FINAL ENVIRONMENTAL IMPACT REPORT

Final Environmental Impact Report

PLAN BAY AREA 2050+

**Regional Transportation Plan (RTP)/
Sustainable Communities Strategy (SCS)**

Figure 18. Urban boundary lines across alternatives

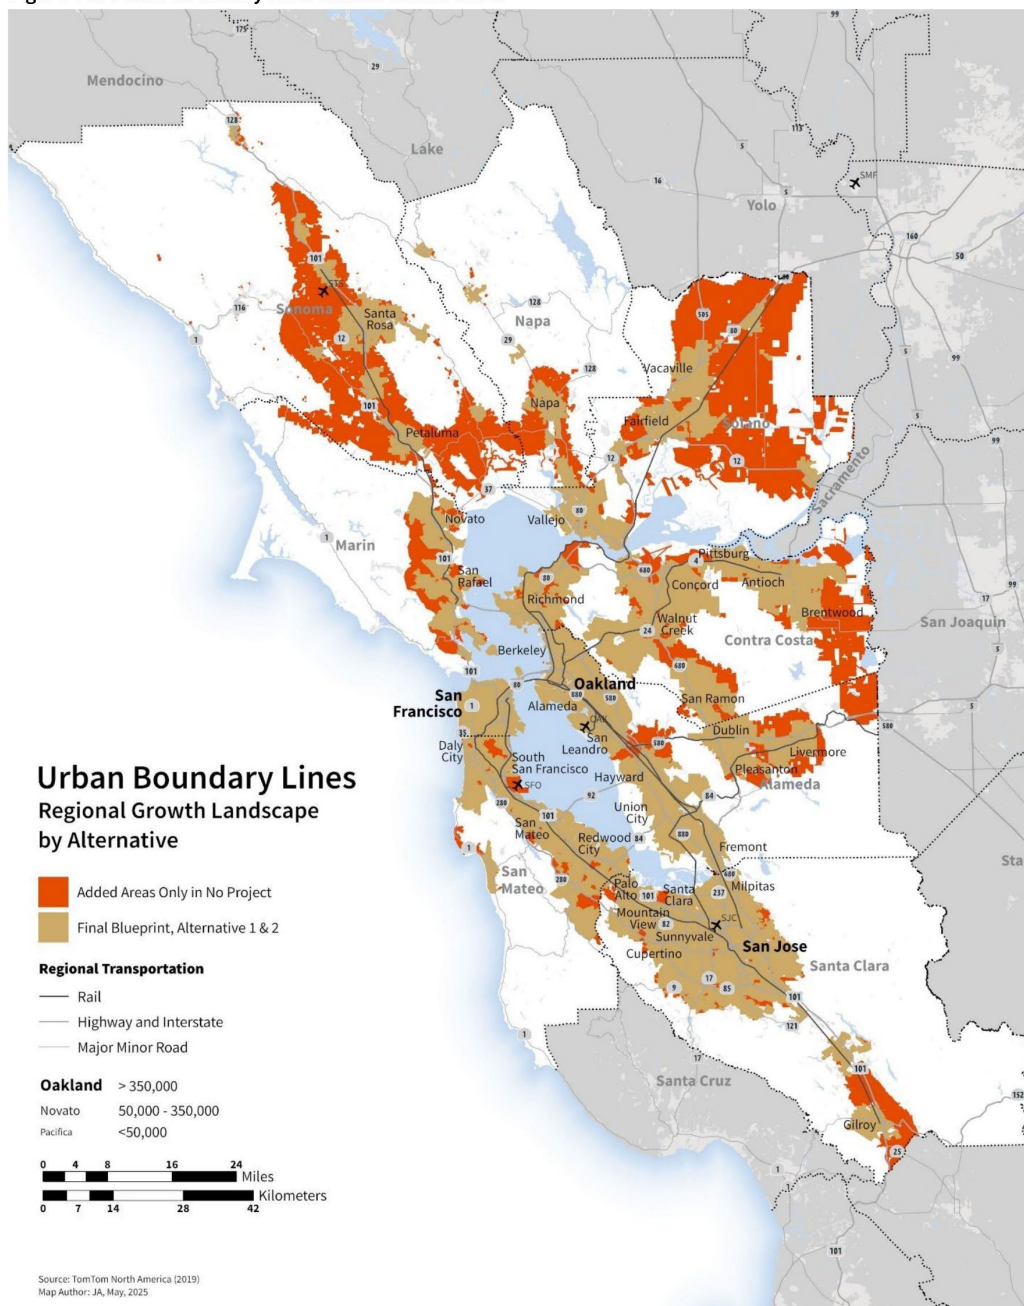
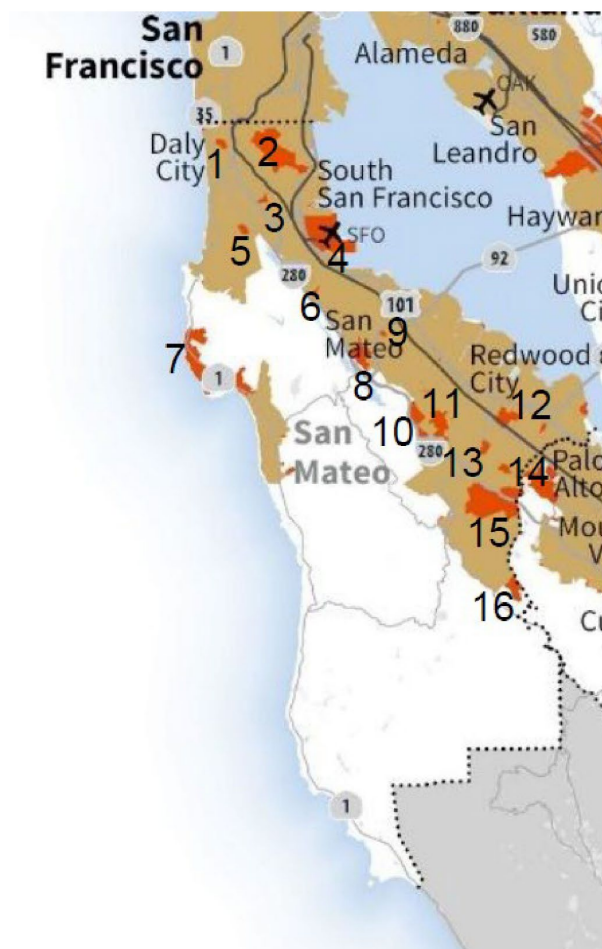
1) Figure 18, "Urban boundary lines across alternatives" (Draft Forecasting and Modeling Report, p. 64) shows the Urban Boundary lines in the nine Bay Area Counties. For San Mateo County, several unincorporated areas that are already urbanized and within the Spheres of Influences of cities in San Mateo County are depicted on the map as "Added Areas Only in No Project." LAFCo encourages the Plan authors to revise this figure and associated analyses (see Figure 1 below), since in San Mateo County, at least, these boundaries do not accurately depict existing urban development. As stated in Strategy EN 4: Maintain Urban Growth Boundary, "The No Project Alternative has weak enforcement of the [urban] boundary, allowing suburban growth to spill past it" (Plan Bay Area 2050+: Draft Forecasting and Modeling Report, p. 63). Figure 18 incorrectly characterizes areas in orange color in San Mateo County as "Added Areas Only in No Project," when in fact, these are existing developed and urbanized communities, some of which are wholly surrounded by one or more cities (see Figure 3). For example, Emerald Lake Hills, North Fair Oaks, and Sequoia Tract are within the Sphere of Influence of Redwood City (see Figure 4). North Fair Oaks, Harbor Industrial Area, and Unincorporated Colma, all urbanized communities, are identified as Priority Development Areas in Plan Bay Area 2050+, but are shown in Figure 19 as being areas that are added in only in the No Project scenario. LAFCo and State law expects, plans for, and encourages these unincorporated communities to eventually annex into cities identified by LAFCo. On the coast, the boundaries of the City of Half Moon Bay include the unincorporated communities of Princeton, Montara,

The comment does not raise environmental issues or concerns regarding the adequacy, accuracy, or completeness of the Draft EIR. The issue identified was a mapping error in Figure 18 “Urban Boundary Lines Across Alternatives,” in the Draft Forecasting and Modeling Report and has been corrected in the updated Forecasting and Modeling report. The MTC Commission and ABAG Executive Board will consider this comment as part of their overall consideration of the proposed plan.

The commenter’s concern regarding the treatment of certain unincorporated areas in San Mateo County resulted from a mapping error in Figure 18, “Urban Boundary Lines Across Alternatives,” in the Draft Forecasting and Modeling Report. The figure incorrectly depicted certain areas as outside the applicable Urban Boundary lines under the proposed plan, while correctly reflecting their treatment under the No Project Alternative. This mapping error has been corrected in the proposed Final Forecasting and Modeling Report.

Figure 2 - Urban Boundary Lines Map with Mark-up of Developed Communities in San Mateo County

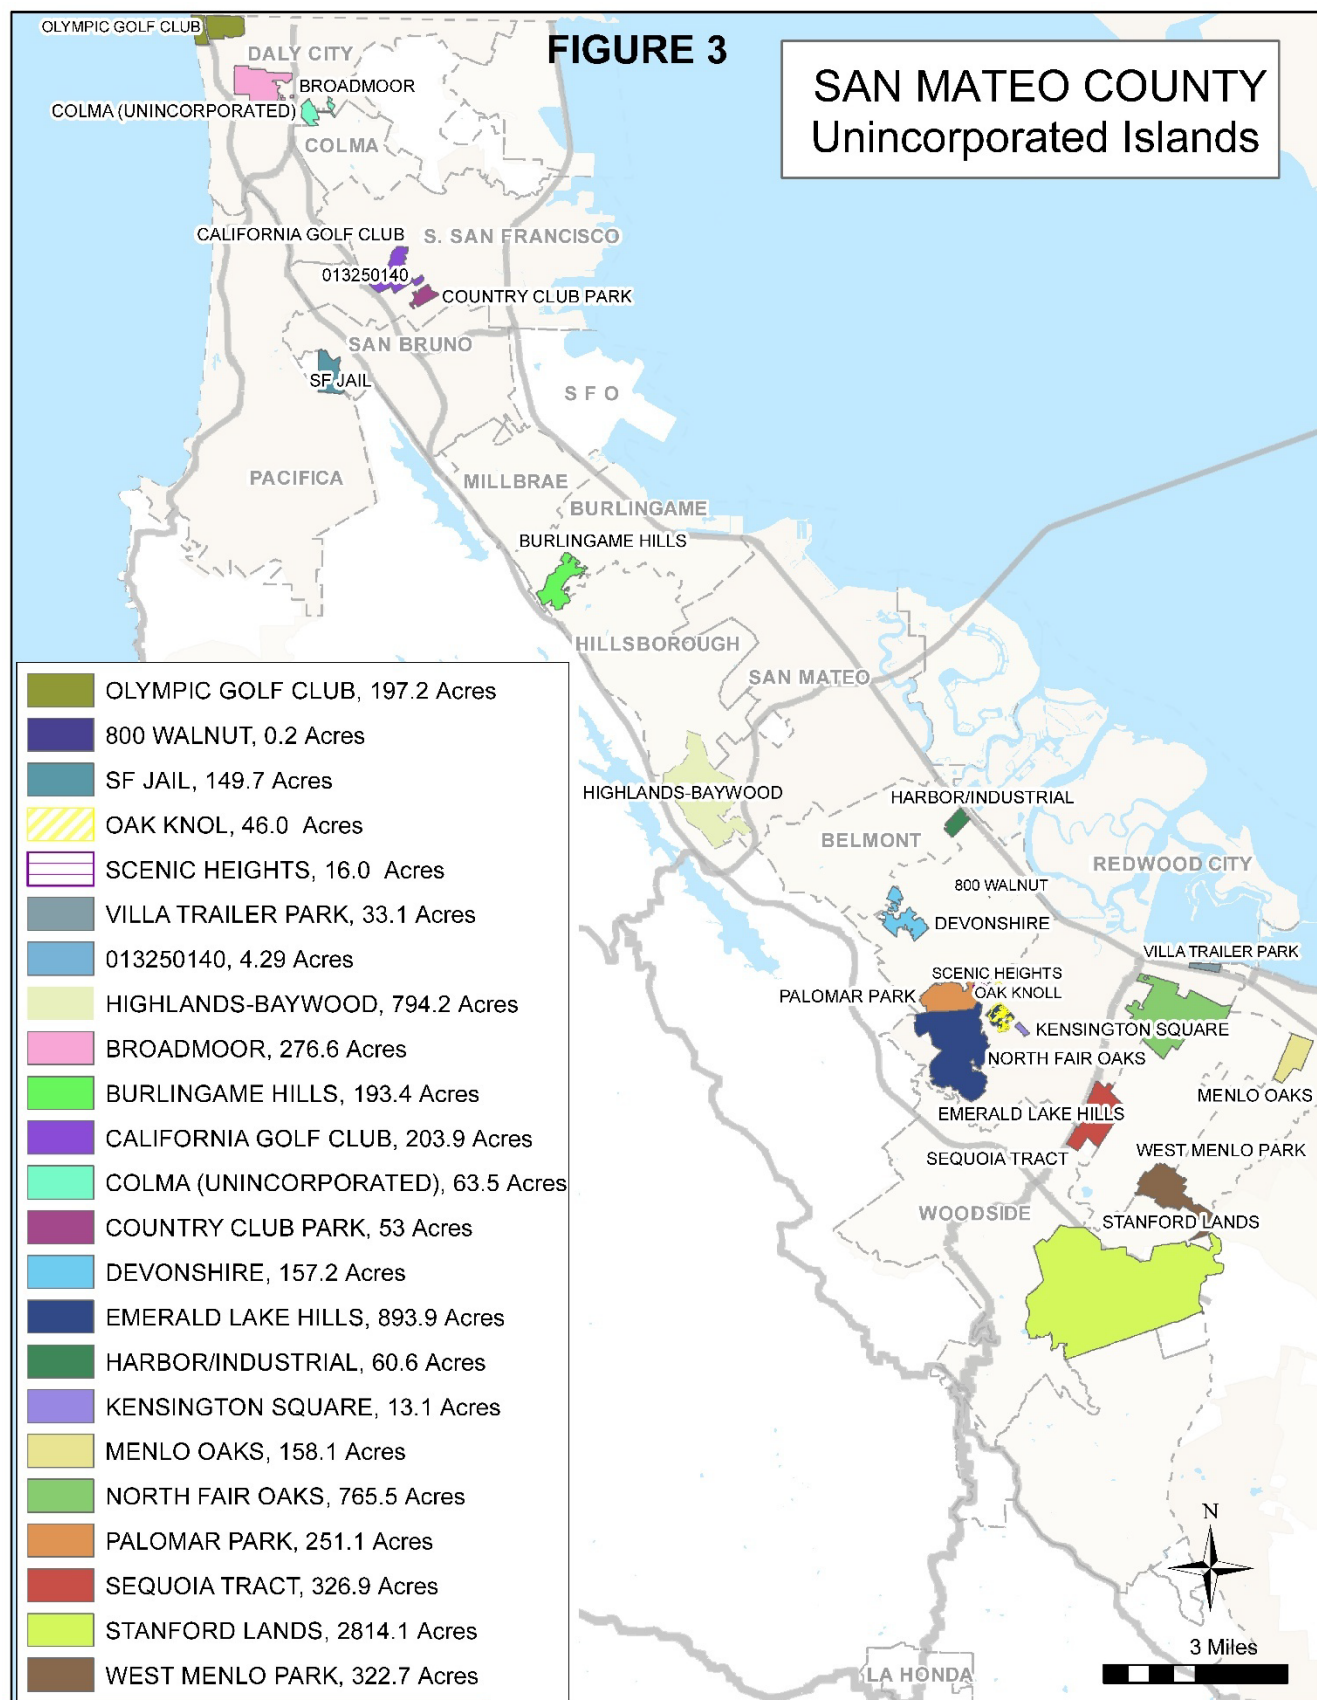
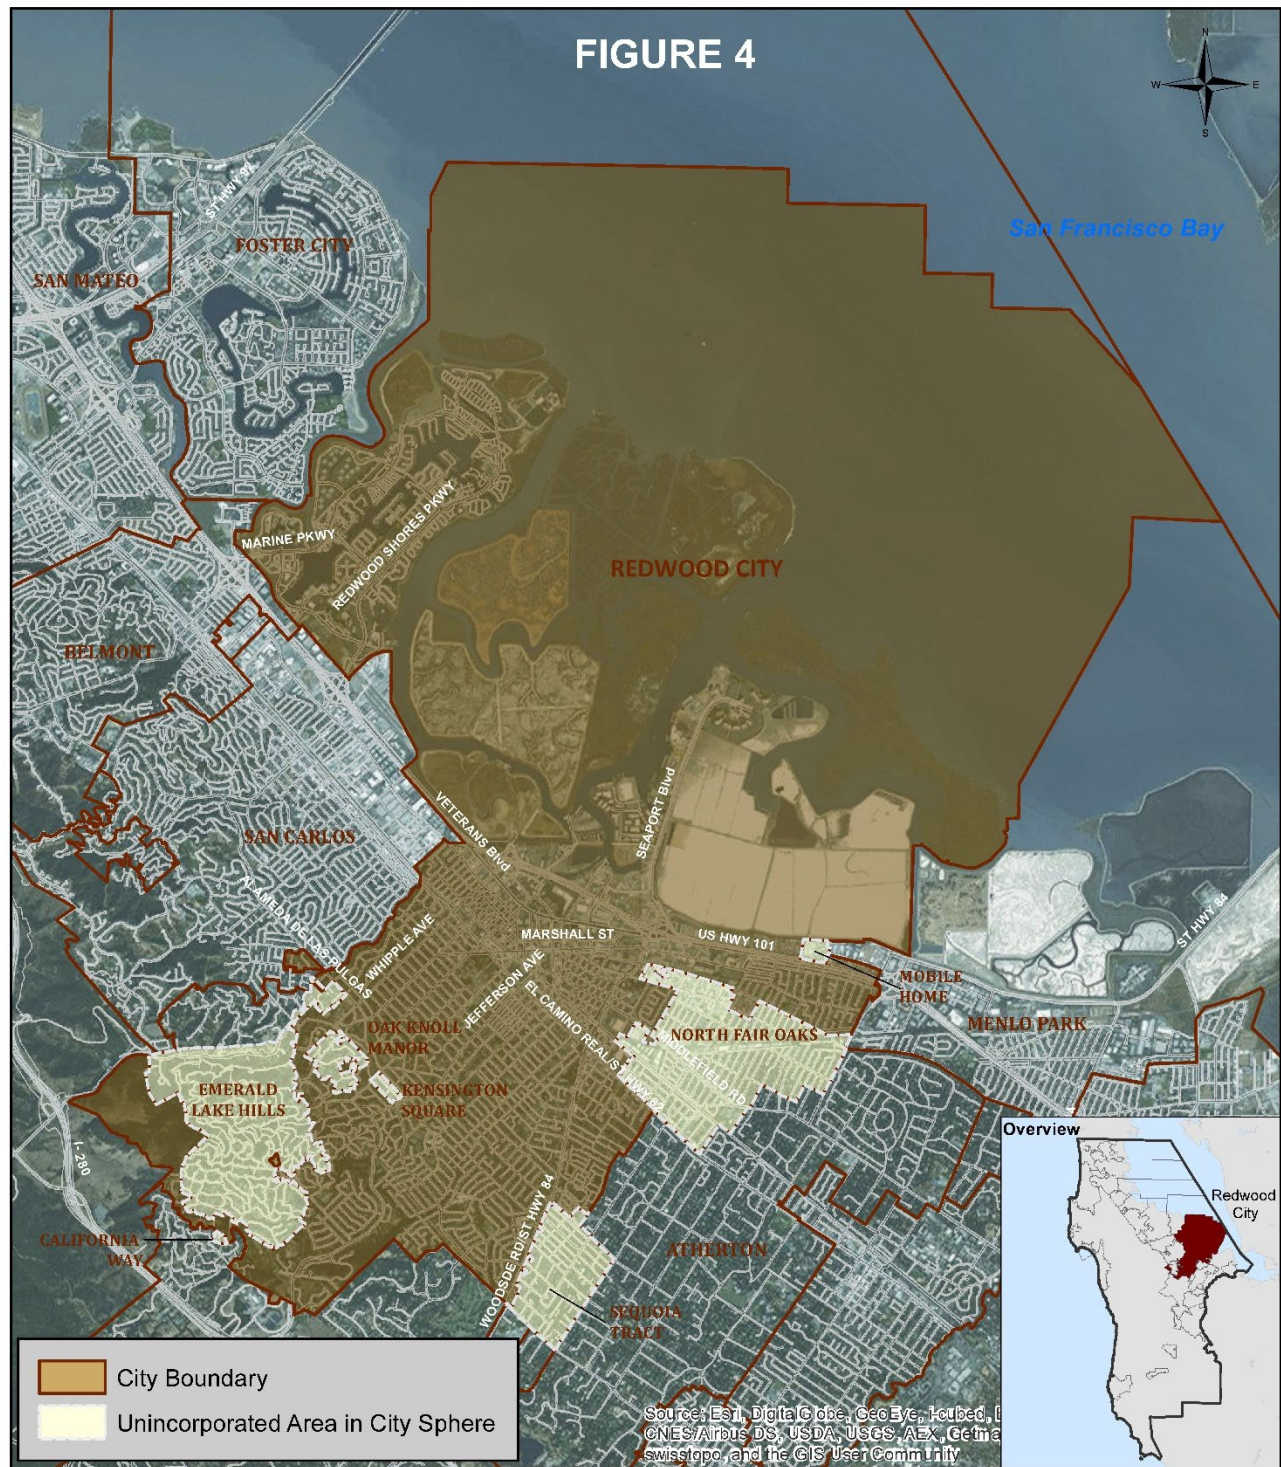
Moss Beach, Miramar and El Granada. These communities are within the Sphere of Influence of the City of Half Moon Bay. In Figure 2 below, LAFCo has identified various developed areas in San Mateo County that have been incorrectly identified as outside urban boundary lines.

The land use modeling underlying both the proposed plan and the No Project Alternative appropriately allows for development. Growth in these areas was not restricted by Strategy EN4. The correction to Figure 18 clarifies the consistency between the modeling assumptions and the plan documentation and does not result in changes to the environmental analysis presented in the Draft EIR. Please refer to Response A9-2 related to the comment letter submitted by the San Mateo LAFCo.

Figure 3-2. Forecasted Population Between Plan Bay Area 2050 and Plan Bay Area 2050+

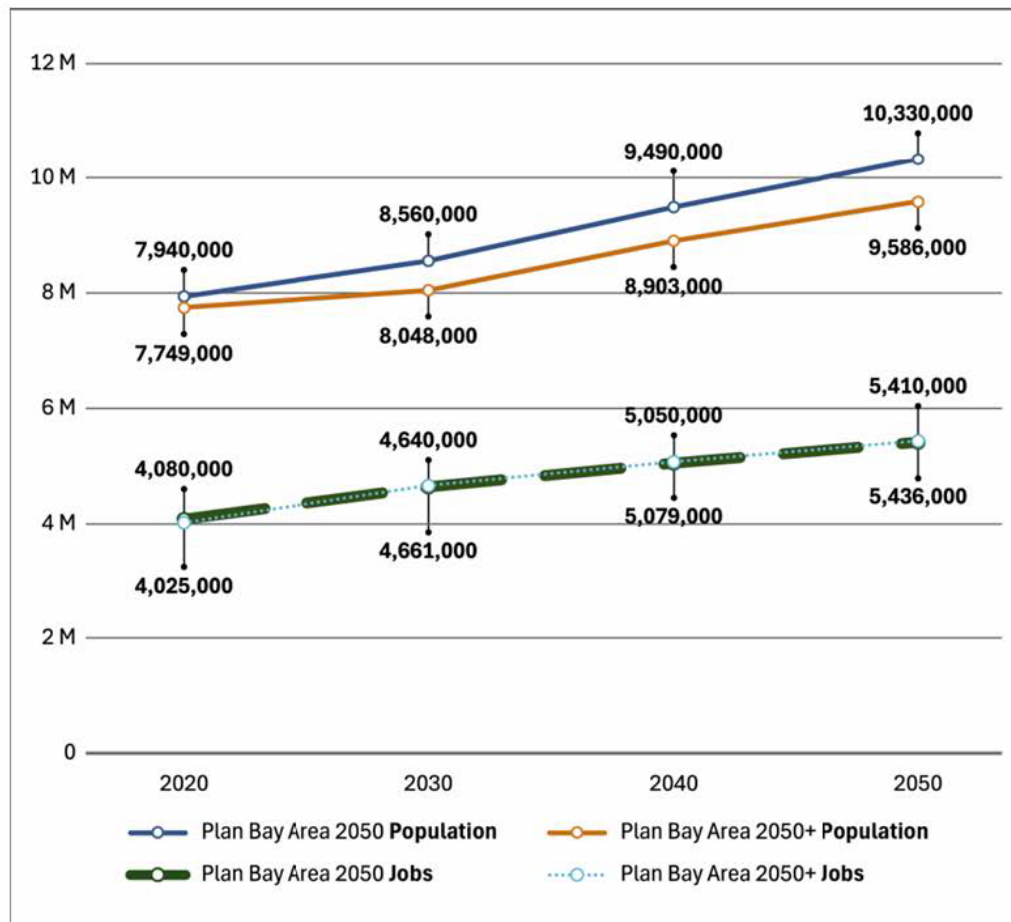
Comment I28-12**MTC's PROJECTIONS OF JOBS ARE CONFUSING, INCONSISTENT, AND OF QUESTIONABLE ACCURACY**

Comparing the population and jobs projections from Plan Bay Area 2050 to those from Plan Bay Area 2050+ produces the following:
